Subject: FW: NYM/2019/0874/LB & NYM/2019/0870/FL The Woodlands, Sleights, Whitby --
Proposed roof lights.
Importance: High

PROJECT: Flat 11, The Woodlands Sleights, YO21 1RY

Drawing: Existing and Proposed Floor Plan

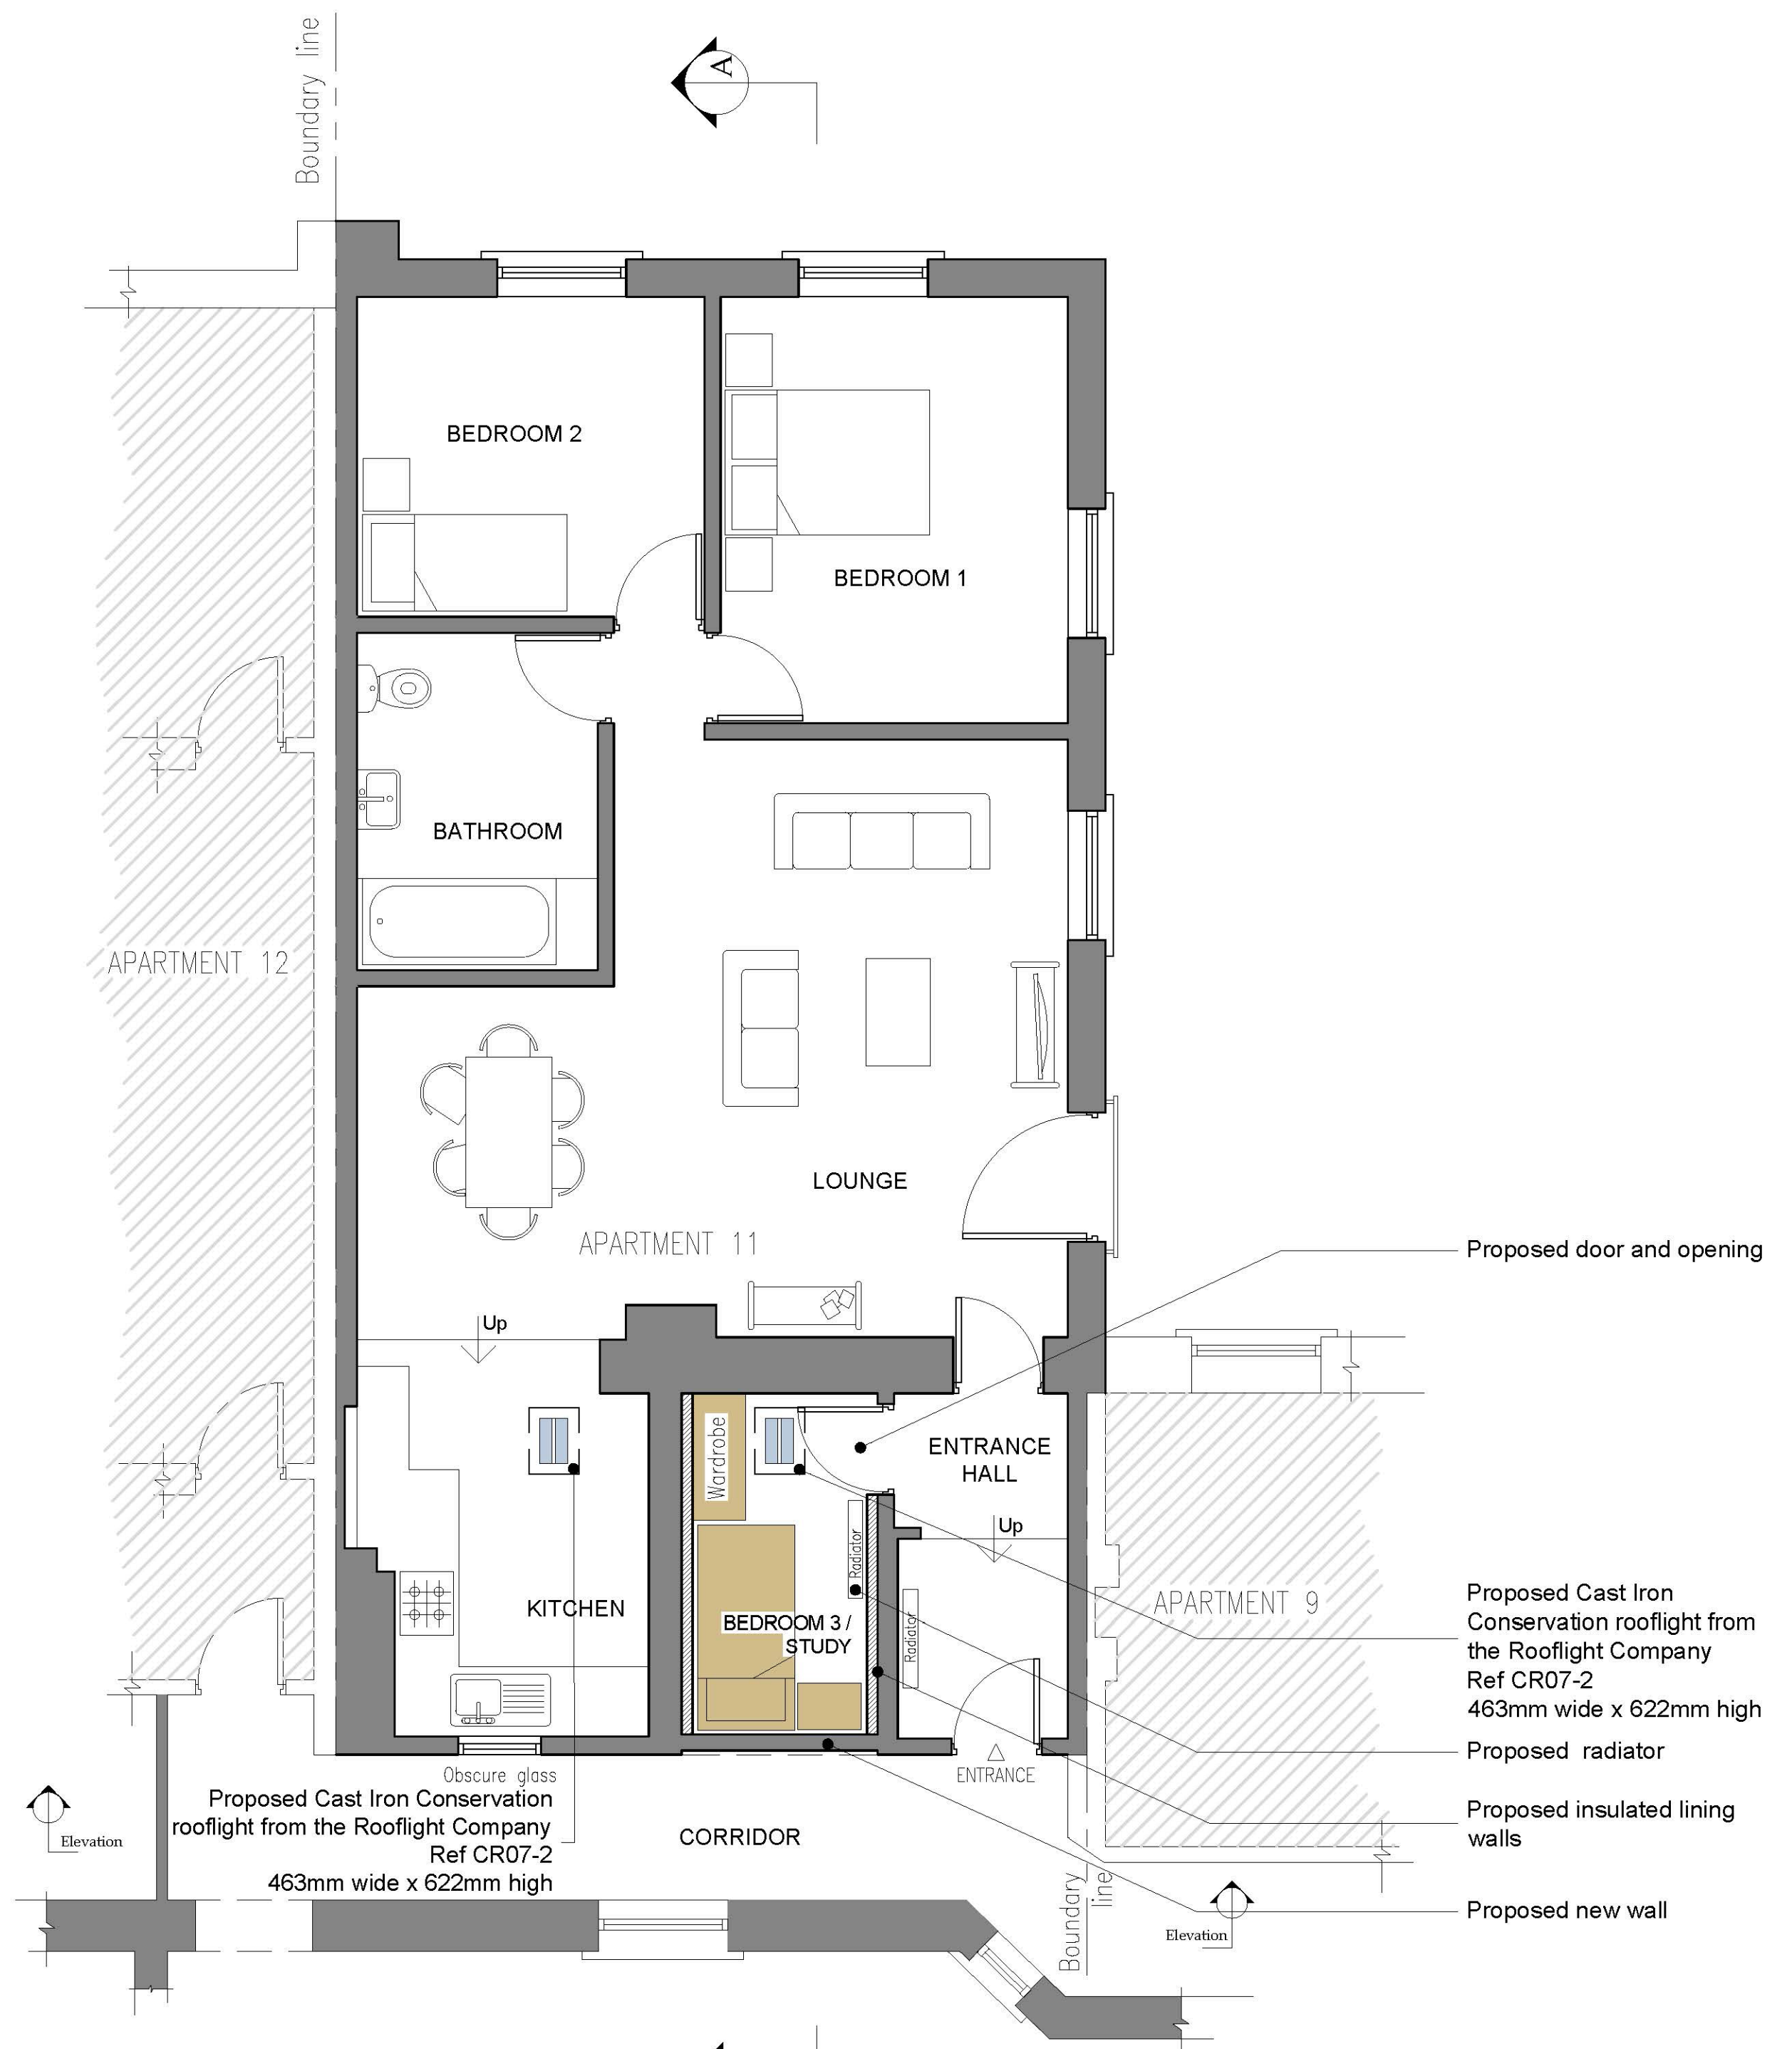
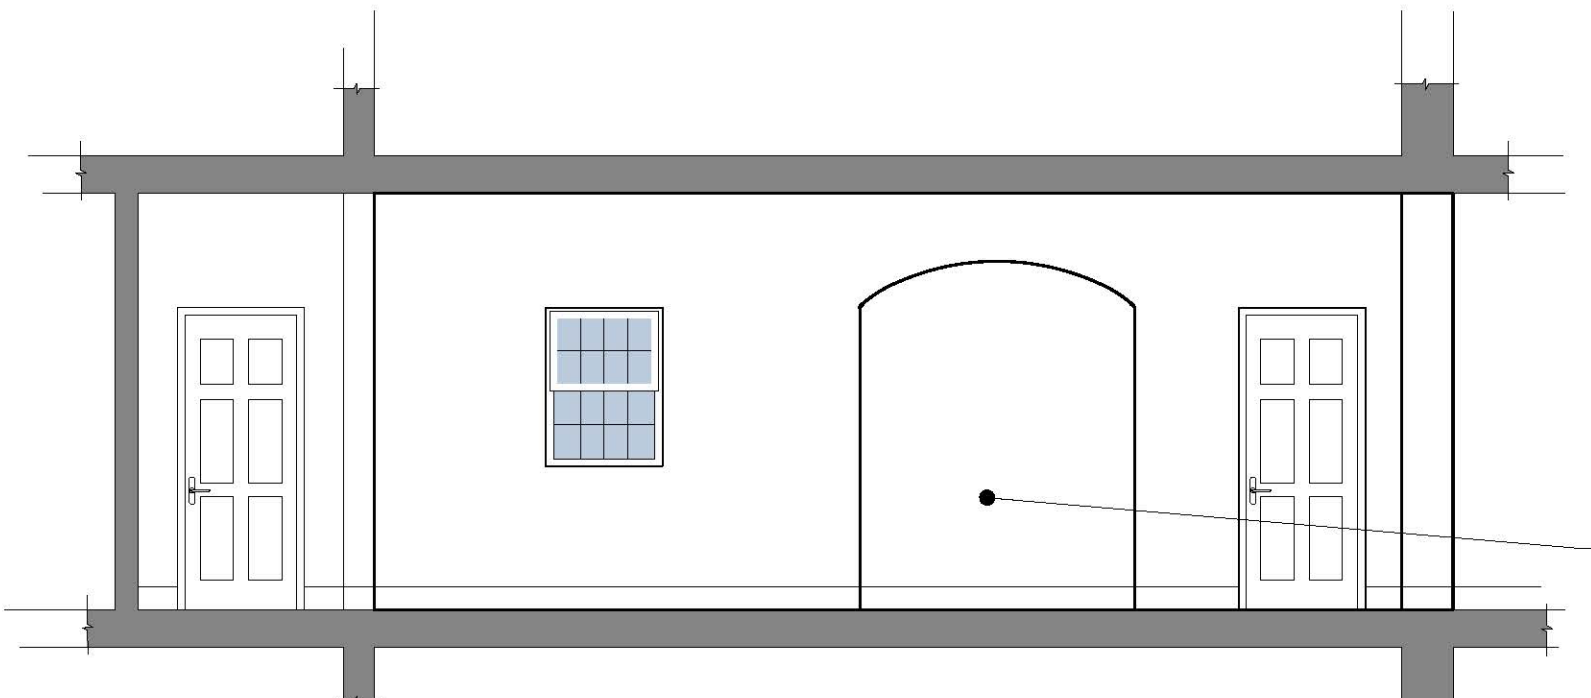
4. It is understood that the symmetry which was referred to in previous correspondence is very important to this elevation and the host property. Therefore this proposal now shows the two small conservation rooflights suggested in your letter which are 2 no. cast-iron rooflights ref CR07-2 463mm wide x 622mm high with a viewable glass size of 263 x 462mm from the Rooflight Company, who are a manufacturer widely considered acceptable for use in Listed buildings within the National Park.

- Proposed door and opening
- Proposed Cast Iron Conservation rooflight from the Rooflight Company Ref CR07-2 463mm wide x 622mm high
- Proposed radiator
- Proposed insulated lining walls
- Proposed new wall

REV	DATE	BY	AMENDMENT
H	19.02.20	MK	Roof light revised
G	06.02.20	MK	Roof light revised
F	06.01.20	MK	Proposed wall revised
E	23.12.19	MK	New wall revised
D	23.12.19	MK	Proposal revised
C	20.12.19	MK	Layout revised
B	05.11.19	MK	Elevations added
A	05.09.19	MK	Notes added
